ATTACHMENT 1
Evaluation of Proposed Change

In accordance with 10 CFR 50.90, "Application for amendment of license or construction permit," Exelon Generation Company, LLC (EGC) requests an amendment to Renewed Facility Operating License No. DPR-30 for Quad Cities Nuclear Power Station, Unit 2. The proposed change revises the values of the safety limit minimum critical power ratio (SLMCPR) in Technical Specification (TS) Section 2.1.1, "Reactor Core SLs." Specifically, the proposed change would require that for Unit 2, the minimum critical power ratio (MCPR) for Global Nuclear Fuel (GNF) fuel shall be ≥ 1.09 for two recirculation loop operation, or ≥ 1.10 for single recirculation loop operation. Additionally, the proposed change would require that MCPR for Westinghouse fuel shall be ≥ 1.11 for two recirculation loop operation, or ≥ 1.13 for single recirculation loop operation. The proposed change is described below.

QUAQ CITIES NUCLEAR POWER STATION, UNIT 2
RENEWED FACILITY OPERATING LICENSE NO. DPR-30

REVISED TECHNICAL SPECIFICATIONS PAGE

2.1.1.3 Reactor Vessel Water Level

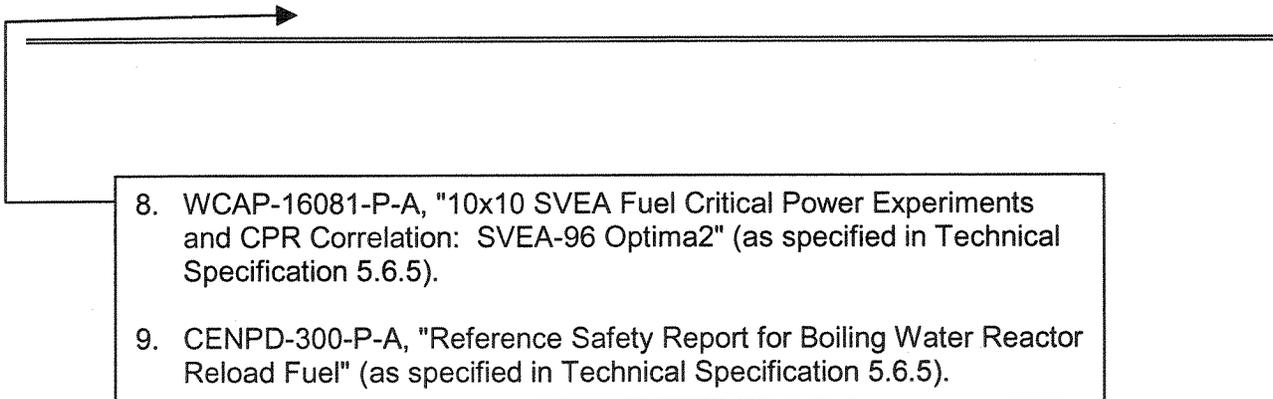
in the fuel vendor's critical power correlation.
~~References 2, 3, 4, 5 and 6~~ describe the methodology used in determining the MCPR SL.

References 2, 3,
4, 5, 6, and 9
